Comments by division and program follow.

## **Soil and Water**

Figure 1: NRCE soil survey mapping in the immediate vicinity of the Bridgeville Commons project.

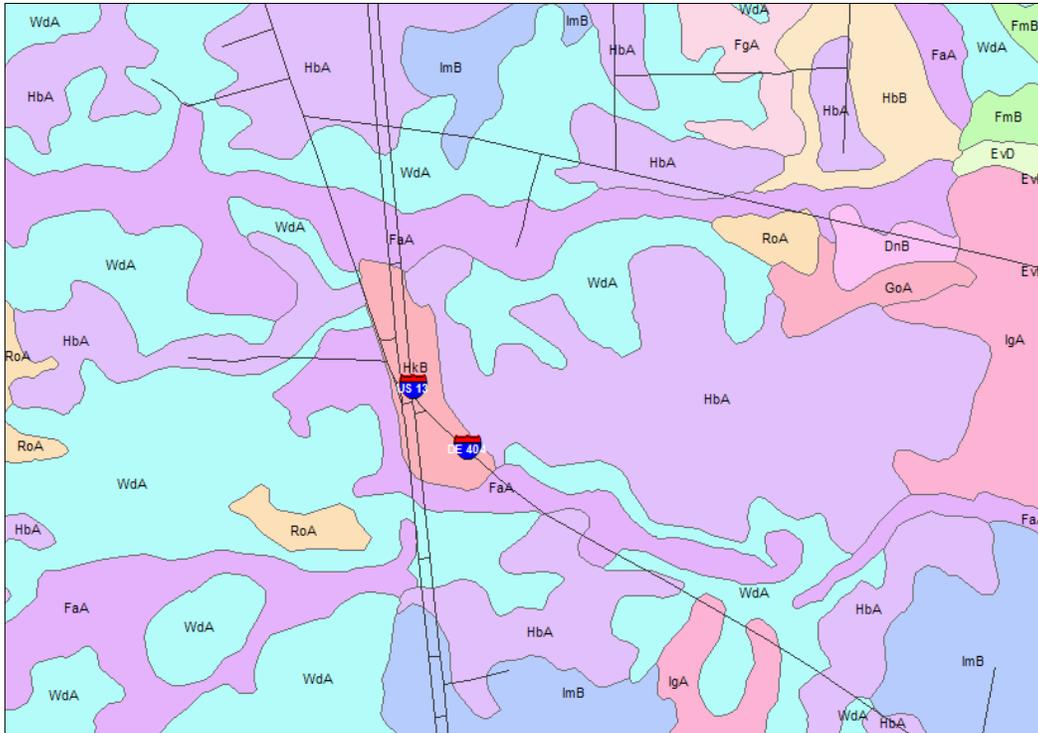
**Soils Assessment.** According to the NRCS soil survey update Hambrook (HbA), Hambrook Urban-Land complex (HkB), Woodstown (WdA), and Fallsington (FaA) were mapped in the immediate vicinity of the proposed construction. Hambrook is a well-drained upland soil that, generally, has few limitations for development. Hambrook Urban- Land complex is a soil that has been extensively modified from grading, filling, or excavation practices, and may have variable site-specific limitations. Woodstown is a moderately well-drained soil of low-lying

uplands that has moderate limitations for development. Fallsington is a poorly-drained wetland associated (hydic) soil that has severe limitations for development.

**Map 1**

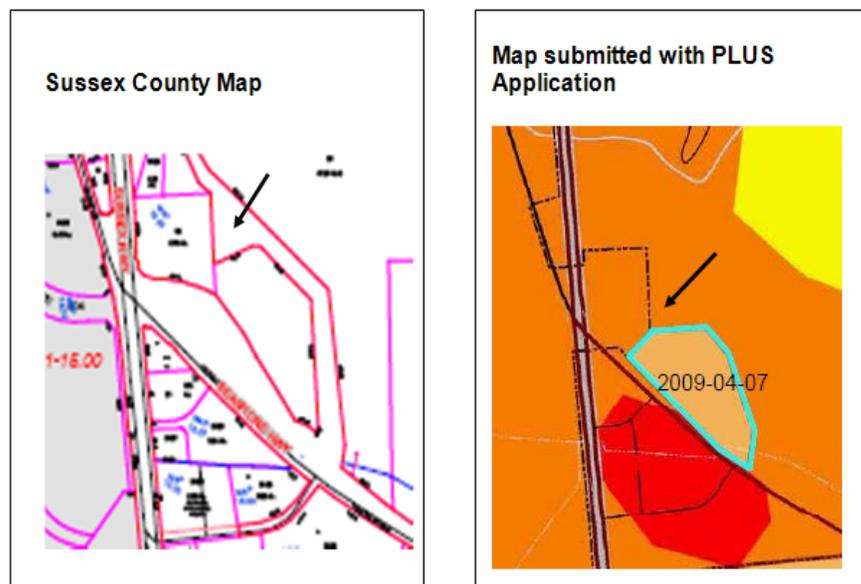
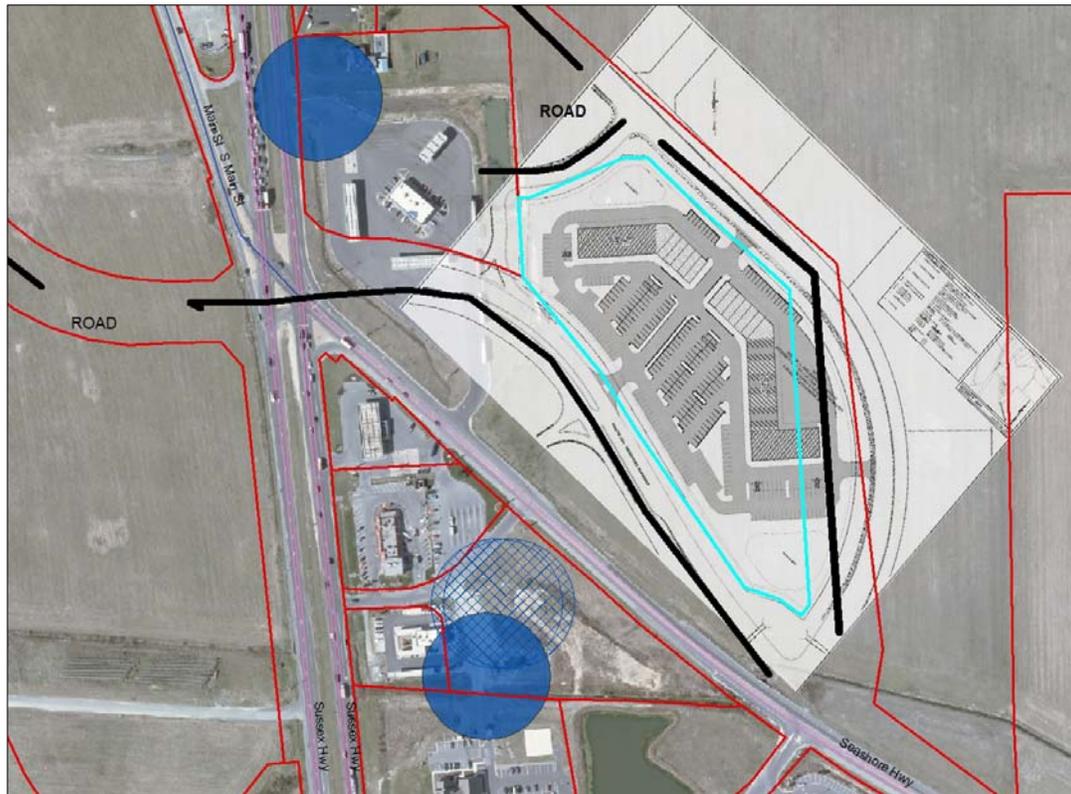
**Water Resource Protection Areas.** The DNREC Ground Water Protection Branch (GPB) has determined that the project does not fall within any delineated wellhead protection area or an area of excellent groundwater recharge potential. However, we did find a discrepancy between the concept plan submitted with the application and the size of the parcel.

The size and shape of the parcel does not match the size and shape of the tax map parcel (TMP) found on the Sussex County website (Map 1). The parcel is approximately 9.36 acres. Efforts to geo-reference the concept plan in ArcMap were unsuccessful. Only the western and southern corners aligned with the TMP (Map 2). Recent visits to the area confirm that the DelDOT easements are paved.

It appears that the site plan was drawn from the DelDOT concept map of the area (Map 3). *GPB recommends a site visit to determine where the parcel lies.*
